**REVIEW OF WAPPA - A WASTE PACKAGE
SYSTEM PERFORMANCE CODE**

Prepared by the Nuclear Waste Management Division
D. G. Schweitzer, Head
Department of Nuclear Energy, Brookhaven National Laboratory
Associated Universities, Inc.
Upton, New York 11973

Prepared for the U.S. Nuclear Regulatory Commission
Office of Nuclear Materials Safety and Safeguards
Contract No. DE-AC02-76CH00016
FIN No. A-3164

Figure 2.0 Geometrical representation of the waste form as a line source surrounded by the engineered barriers of the waste package.

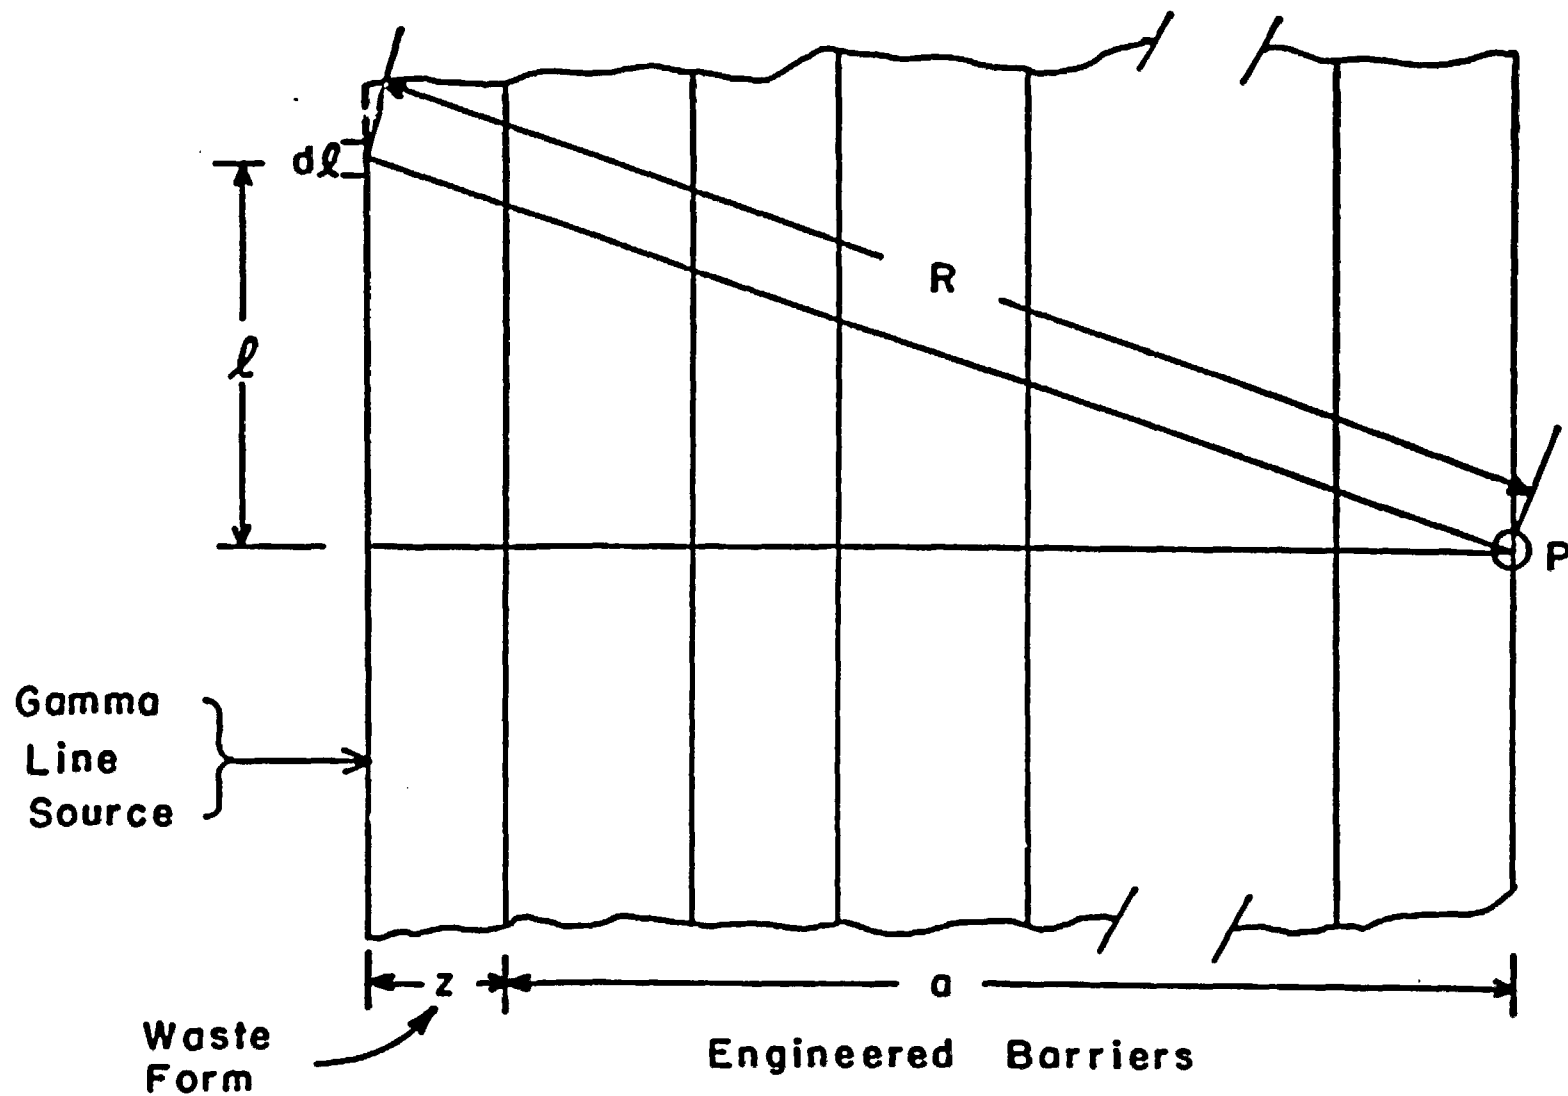
Viewing Figure 2.0, and noting that WAPPA approximates the gamma radiation from the cylindrical waste form as originating from an infinite line source, the error made in WAPPA can be explained. For a gamma ray originating within the line segment dl , it must travel a distance R to reach point P . However, WAPPA calculates the buildup factor based on the normal distance between the line source and point P , the distance $a+z$ in Figure 2.0. Because $(a+z) < R$ and the buildup factors increase with distance, this assumption is non-conservative. Heuristic arguments,^[2] indicate the calculated flux will be within a factor of 10 of the flux obtained using the distance R in calculating the buildup factor. Considering the uncertainties in the entire calculation and the fact that corrosion or leaching will be enhanced by less than 20 percent for an order of magnitude increase in gamma dose, this error may not be significant, but it should be addressed in the code manual.

Furthermore, although WAPPA claims to use standard formulae, the expression for the buildup factor uses slightly different definitions for the

empirical coefficients when compared to the definitions found in the Reactor Shielding Design Manual,^[1] the reference for buildup factors cited by WAPPA.

and the equations are similar. However, this discrepancy is not pointed out in the manual.

Figure 2.1 Typical waste form and canister design (Adapted from Ref. 8).

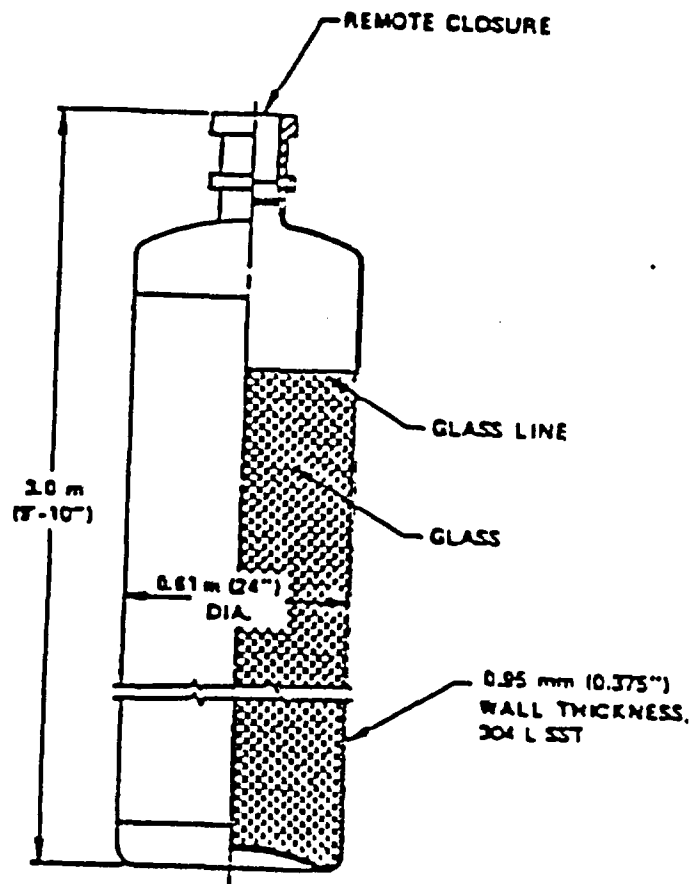
With reference to Figure 2.1, which reports a typical waste package design for high-level waste, it appears that a weak area in the canister structure is the neck area. In that area the metal is not supported by the waste form and the neck shape favors concentration of stresses. Thus, crushing of the air gap appears to be an important failure mode which ought to be addressed. Stresses may also concentrate at the bottom of the canister at the welds between the base and the rest of the metal, thus causing the base to detach. This failure mode should also be addressed.

Figure 2.2 Schematic representation of oxide thickness versus time. WAPPA considers thickness as a function of temperature and time.

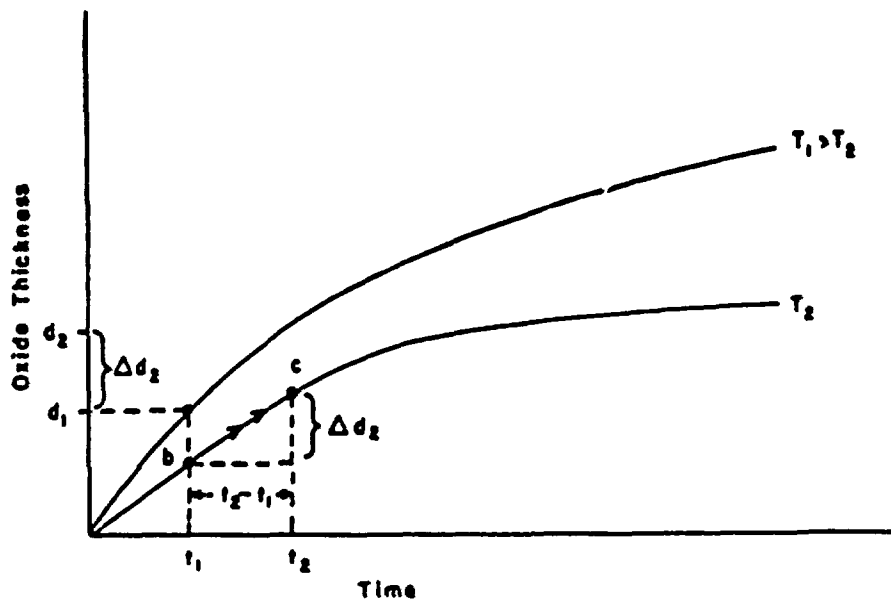
The method of solution used in WAPPA for calculating oxide thickness is most easily understood while viewing Figure 2.2, a plot of oxide thickness versus time for two temperatures. For the initial time step, time zero to time t_1 , the system is at temperature T_1 and the oxide grows to a depth, d_1 . In the subsequent time step, time t_1 to time t_2 , the system temperature has been updated and is T_2 . WAPPA calculates the incremental oxide growth, Δd_2 , as the amount of growth that would have occurred over the time interval t_2-t_1 provided the system had been held at temperature T_2 for the entire calculation time. This growth is represented by the curve through points b and c on the graph. The total oxide thickness is obtained by summation of d_1 , the oxide thickness and Δd_2 , the incremental growth. Viewing each time step as a new initial value problem, it is seen that the WAPPA code changes the "initial condition" for oxide thickness at each time step. Since growth rate is a function of thickness, this procedure is incorrect.

Figure 2.3 Improved oxide thickness calculation considers thickness as a function of temperature and previous history.

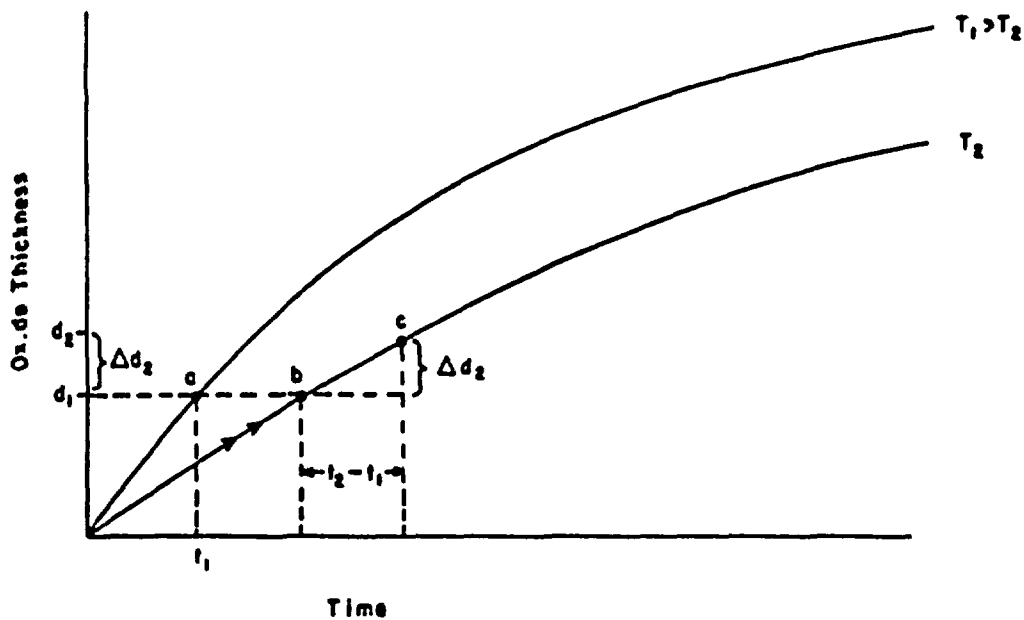
A better solution procedure is schematically represented in Figure 2.3. Here, after the oxide has grown to a depth d_1 at temperature T_1 , time is advanced to the next time step and the temperature is updated and is T_2 . In this case, growth of the oxide is calculated starting from a depth d_1 on the isothermal curve for temperature T_2 . This is point b in Figure 2.3. Growth progresses along this isothermal curve for a time period corresponding to the

length of the time step, $t_2 - t_1$. This is represented by the path between points b and c. The new oxide thickness is the sum of d_1 , the initial thickness, and Δd_2 , the incremental growth. This model takes the viewpoint that corrosion rate is a function of temperature and oxide thickness whereas the WAPPA model views the corrosion rate as a function of temperature and time.
